# Mask Set Errata for Mask 1M25D

This mask set errata applies to the mask 1M25D for these products:

- MC68HC908AP64A
- MC68HC908AP32A
- MC68HC908AP16A
- MC68HC908AP8A

**Figure 1. Typical ADC Error Count**

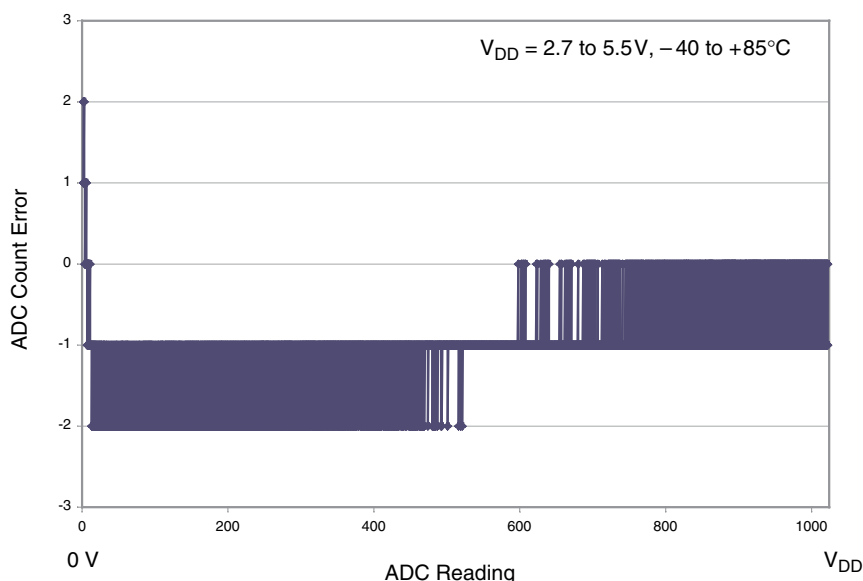
The 10-bit ADC conversion result for 0V input (zero input reading) is \$000, \$001, \$002, or \$003; not the specified \$00 or \$01. With inputs of 5 mV and above, the ADC is within the specified accuracy of  $\pm 1.5$  LSB (see [Figure 1](#)).
